ITS upgrade

RUv2 changes

Project	ITS upgrade (W0004592)	Author(s)	M.J. Rossewij
Name	RUv2 changes	Date	1-Dec-2017
Filename	ITS_RUv2_changes.docx	ID	W0004592_001
Printed	11-4-2018 13:49	Status	Concept
		Version	r1
University of Utrecht, Faculty of Science Scientific Instrumentation P.O.Box 80004, 3508 TA Utrecht Tel: 030 2532293 Email: d.killian@uu.nl WWW: http://www.science.uu.nl/instrumentatie/

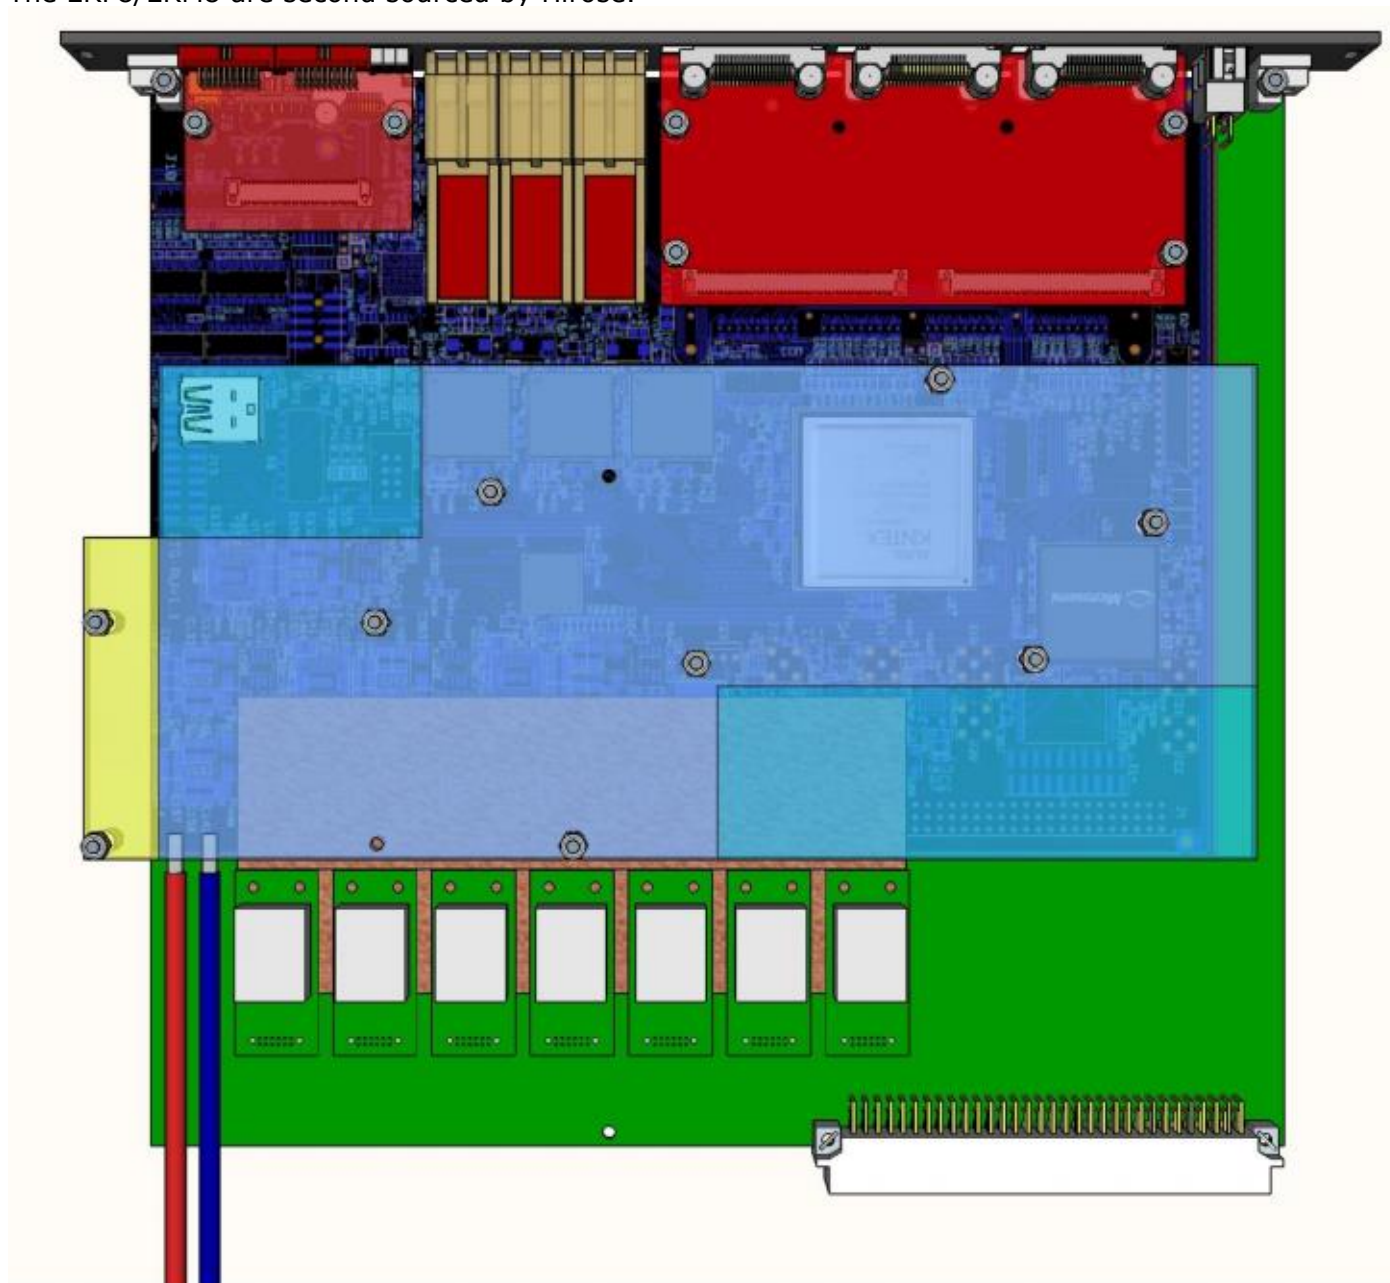
The current transition board connector is a 208-pin samtec QFS/QMS-style connector. The mounting company indicated that they experienced difficulties to ensure all pins are properly soldered. Reducing the size of the transition-board connector (to e.g. 156 pins) improves manufacturability but does not provide sufficient space for the MFT.

It could be an option to replace the single 208-pin samtec QFS/QMS-style connector with 2 ERF8/ERM8 connectors. T.B.I.

2.3	Change RU QFS -> ERF8 transition board connector	Check assembly yield with loopback board & cable plug decision	ERF connectors placed MH still to be added
